Bid 627
New HVAC Modernization Project for (Both) Oxnard and Pacifica High Schools

BID CLARIFICATION ADDENDUM #3

Dated: August 25th, 2020

DRAWING NUMBER: **AC4.0**

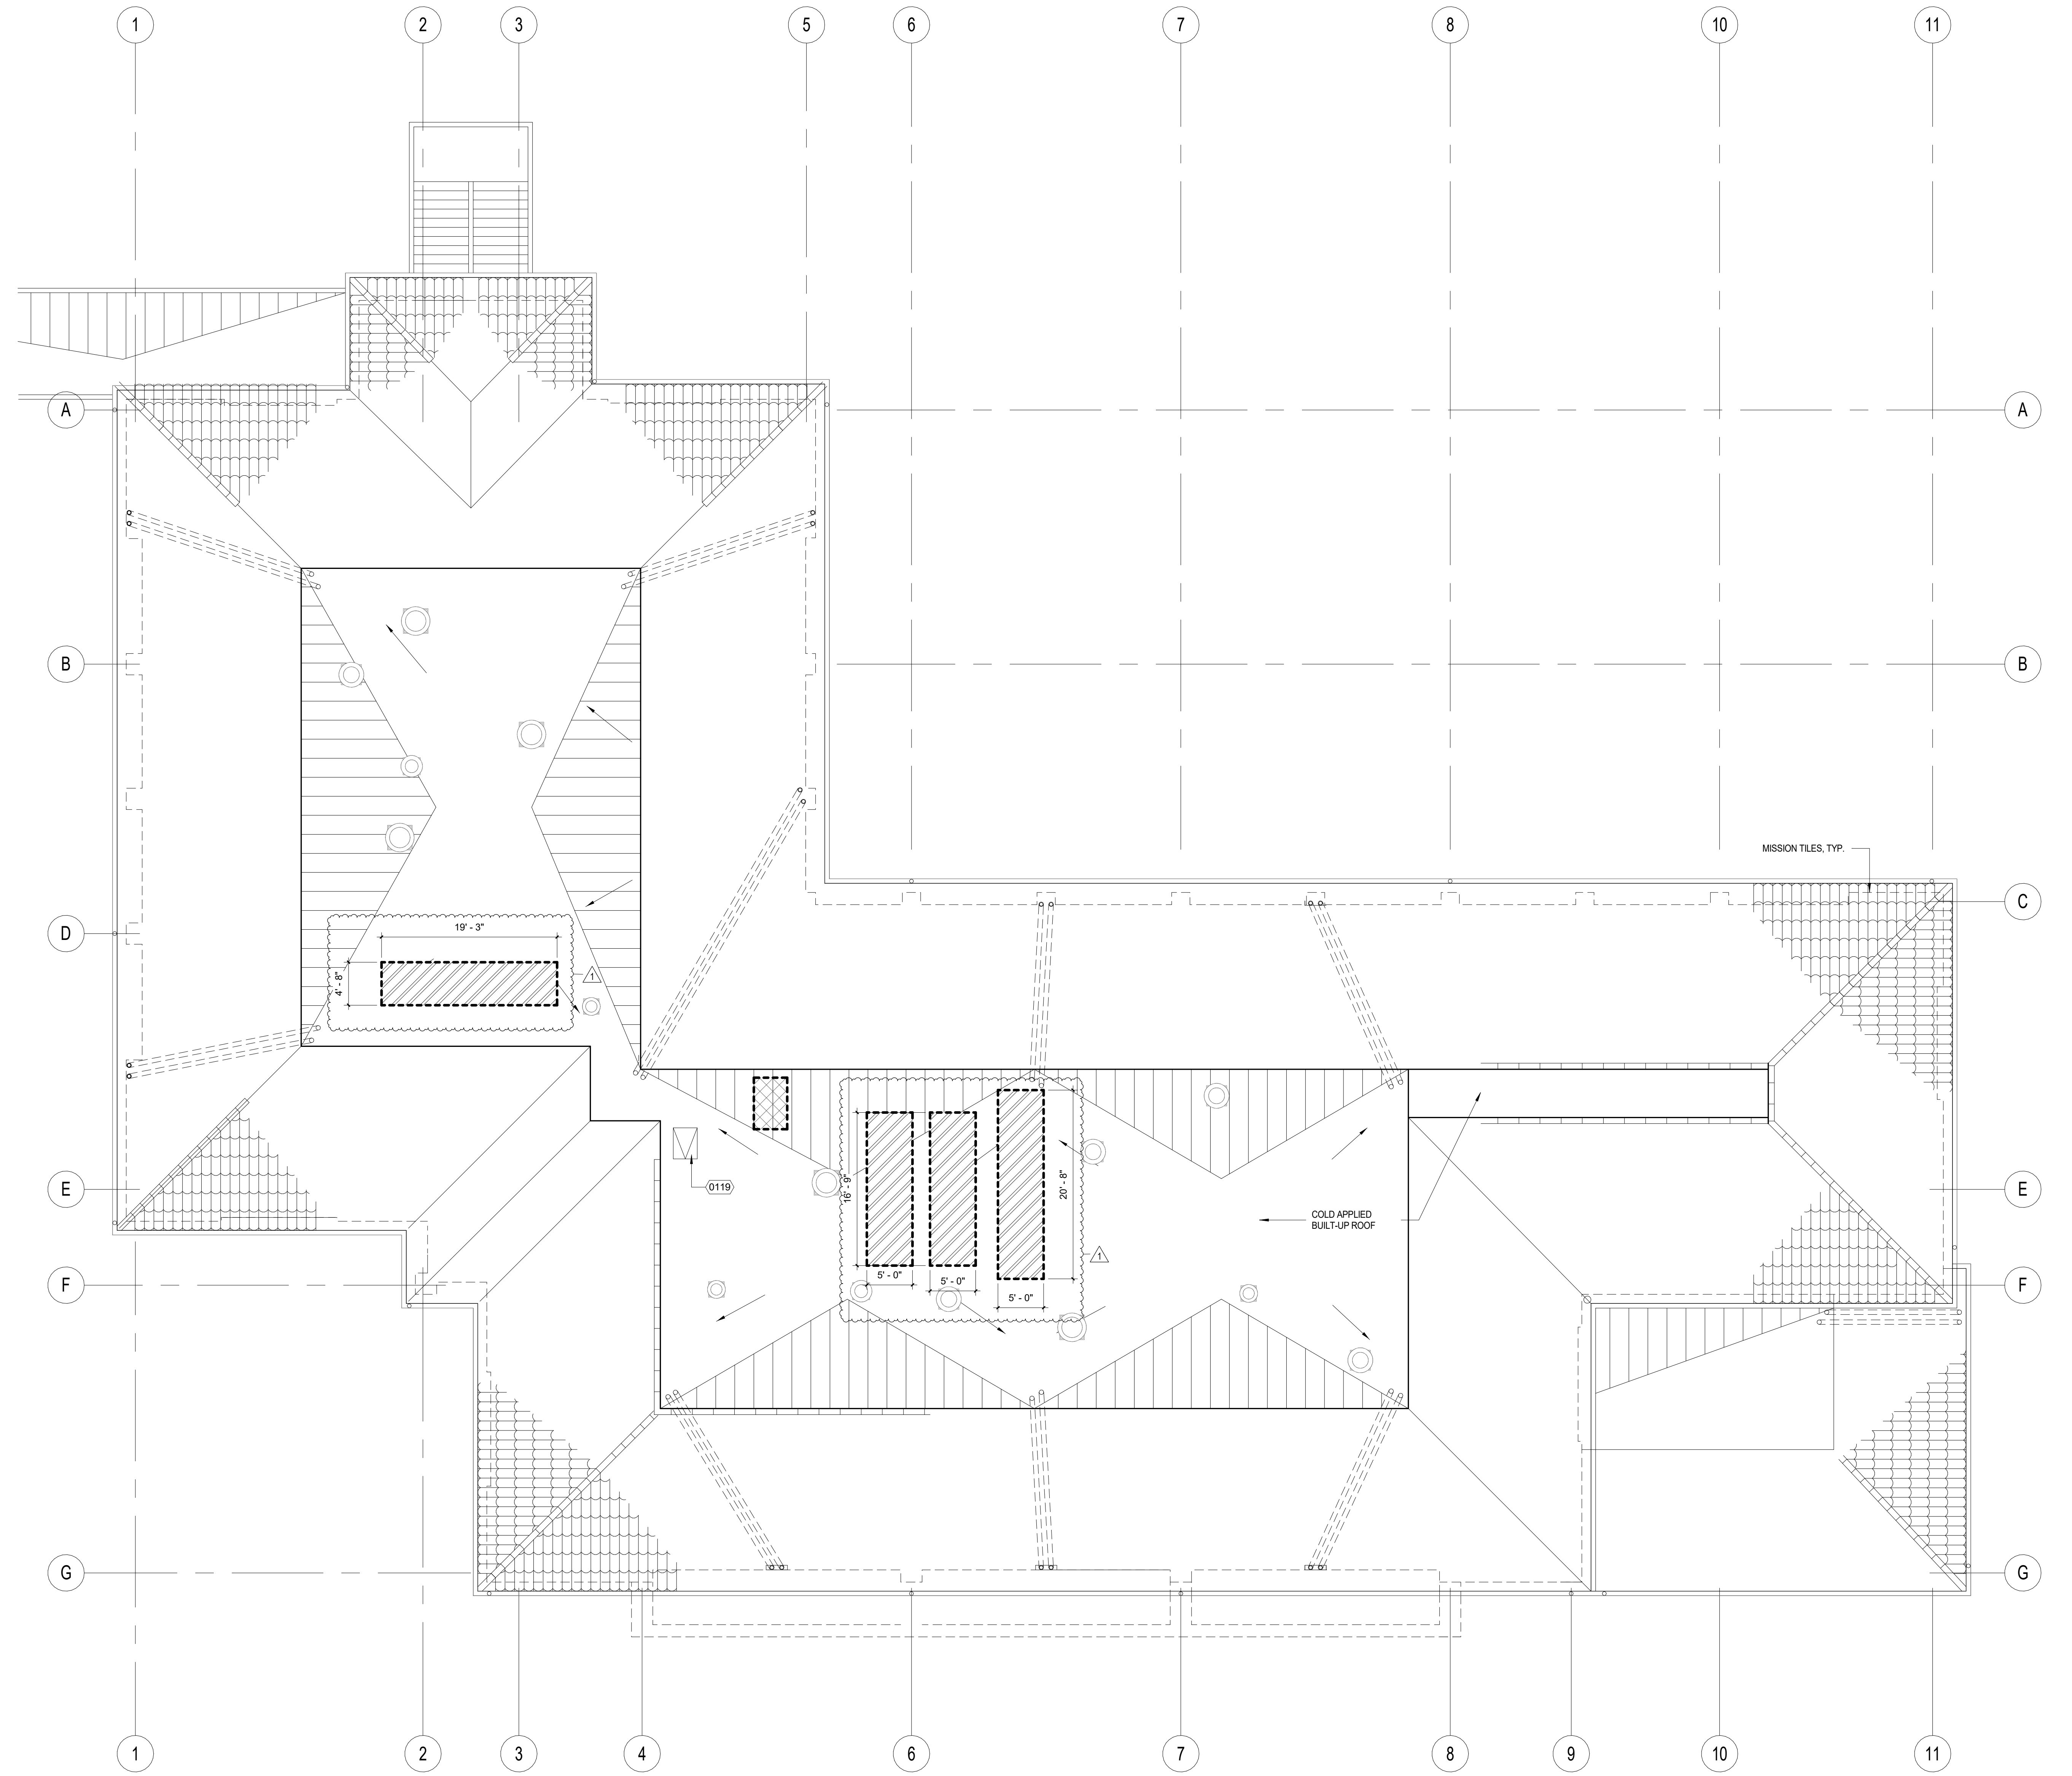
- ### A.
- Replace DSA approved Drawing AC4.0 with in its entirety the attached revised Drawing AC4.0 (Revised hatch pattern and Legend to leave metal decking in place).

DRAWING NUMBER: **AC4.1**

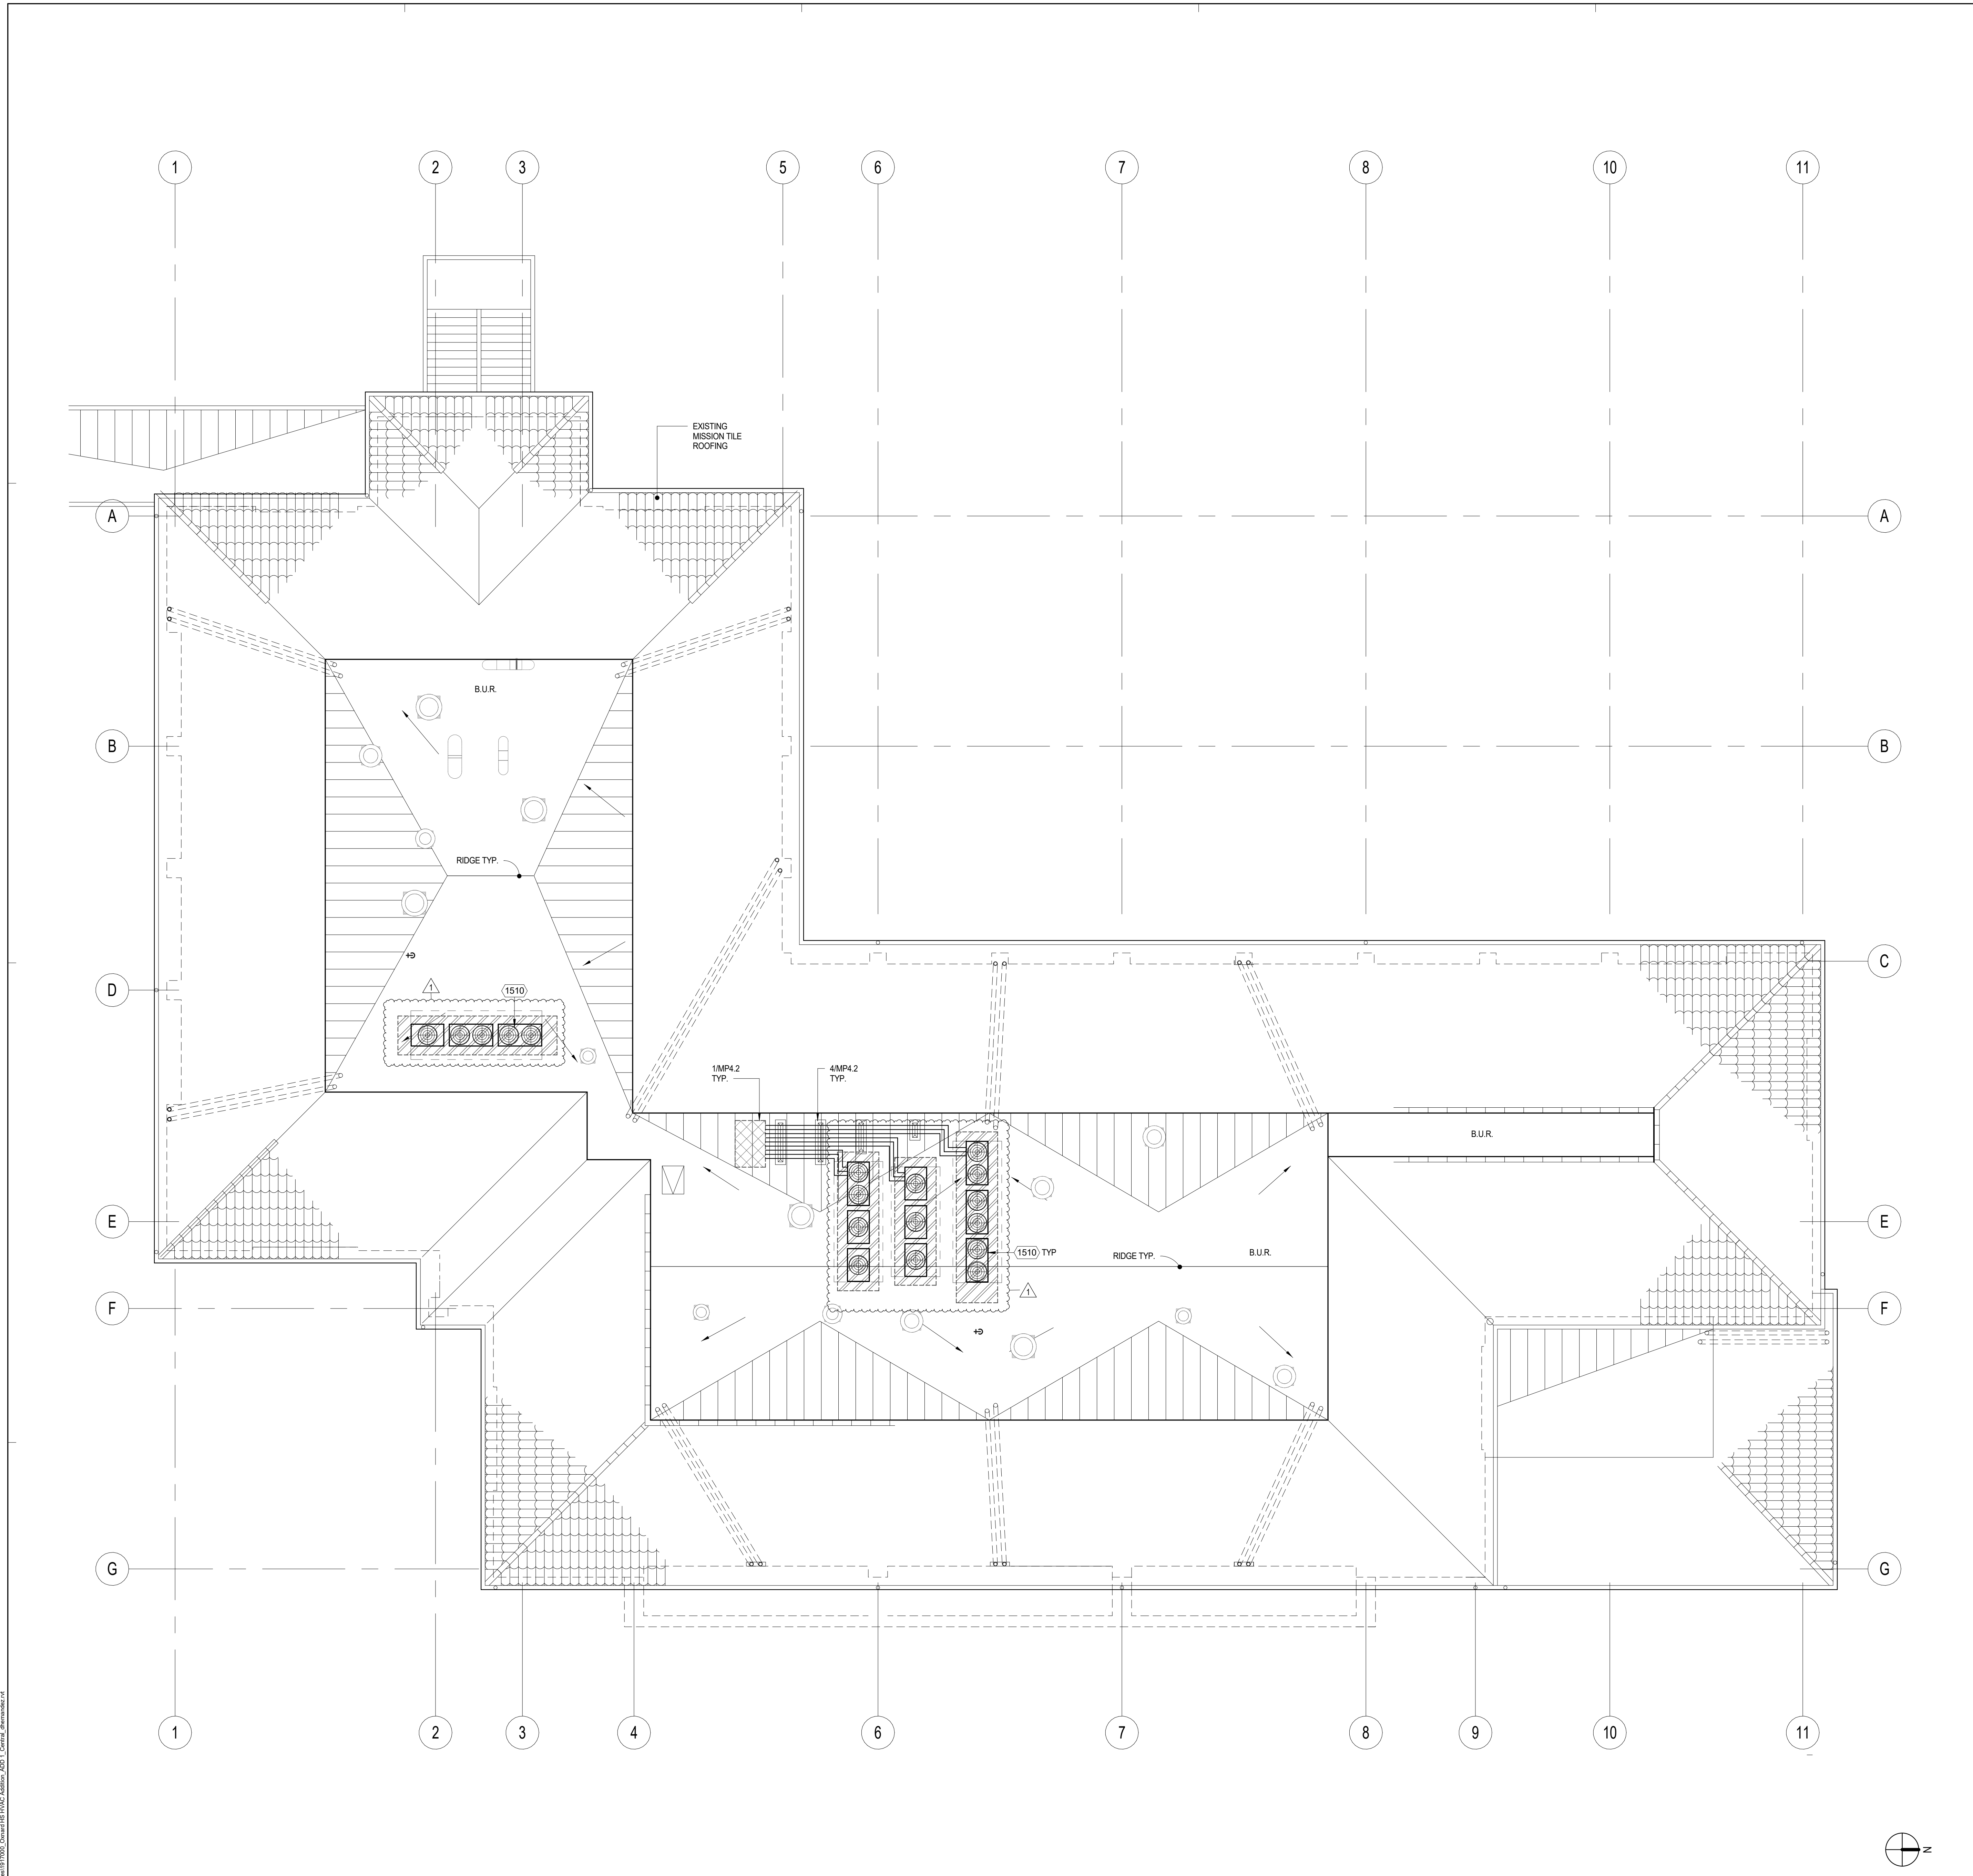
- ### A.
- Replace DSA approved Drawing AC4.1 in its entirety with the attached revised Drawing AC4.1.

1. Revised hatch pattern and Legend to leave metal decking in place.
2. Revise "13/S0.3" to "14/S0.3" in Legend.
3. Revised 12/7.1 to 6/7.1 in Legend.

DRAWING NUMBER: **AG3.1**

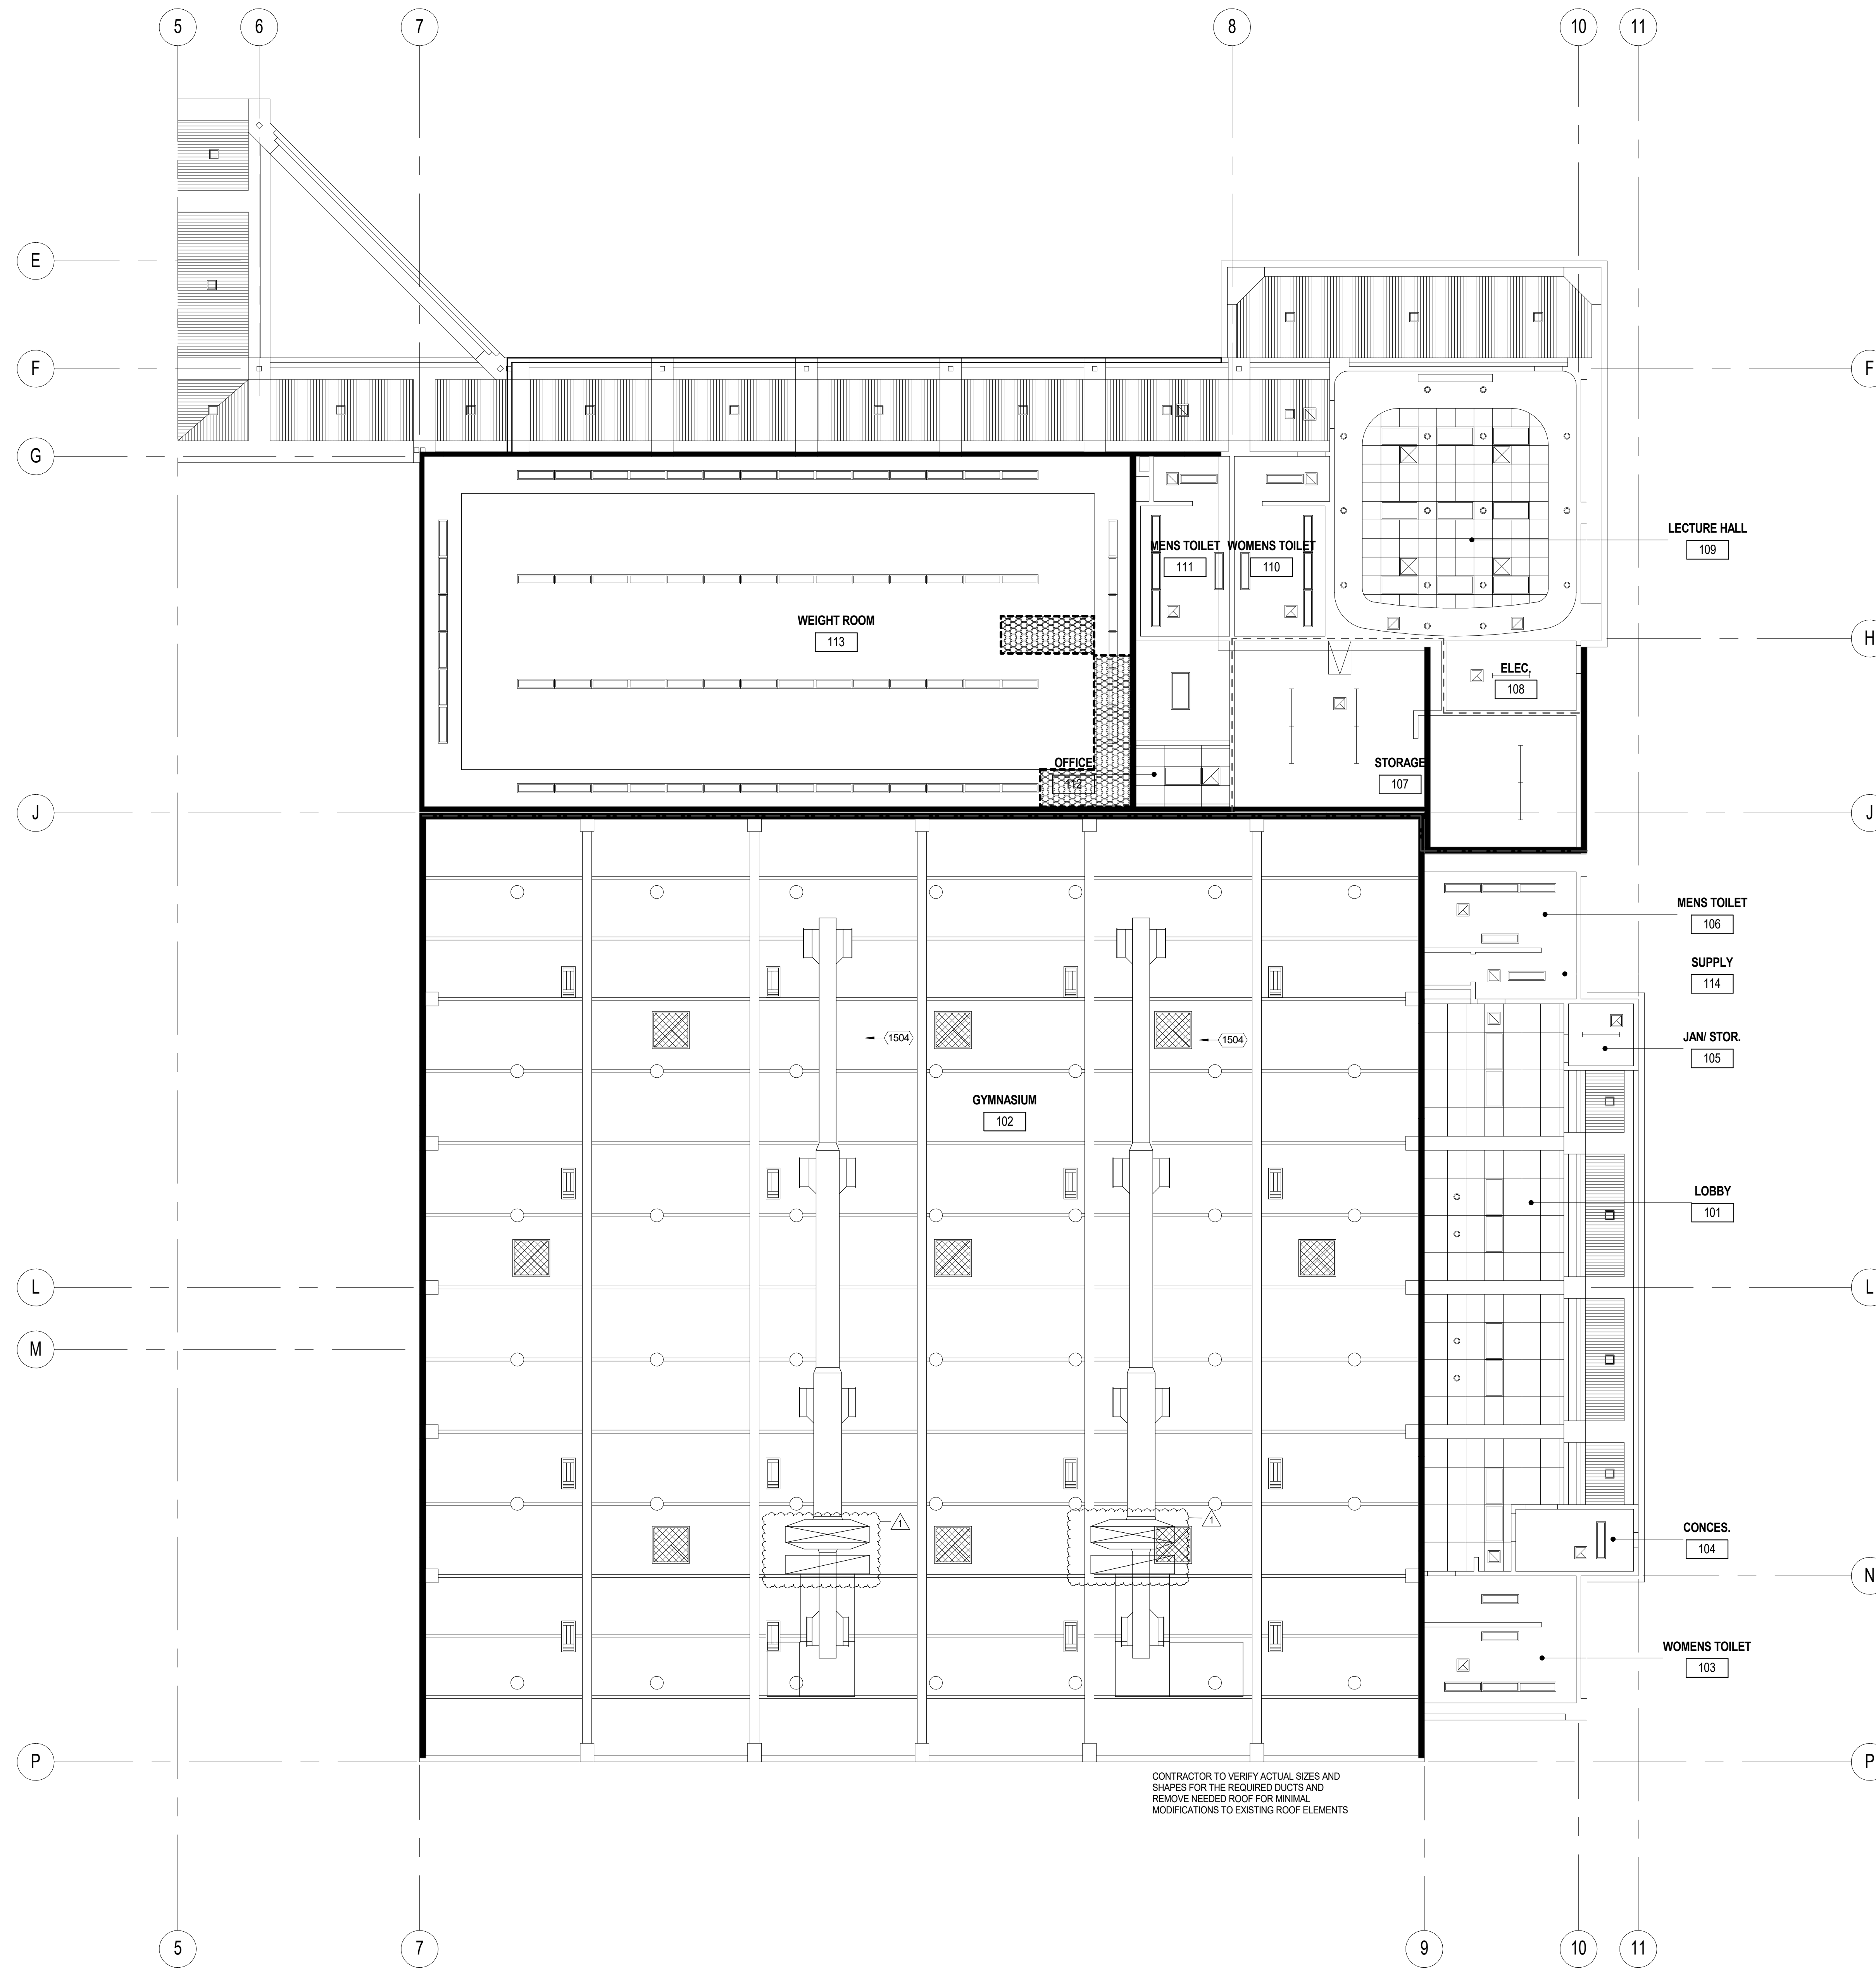
- A. Replace DSA approved Drawing AG3.1 in its entirety with the attached revised Drawing AG3.1 (Updated duct work to match mechanical drawing. Updated notes in Legend).
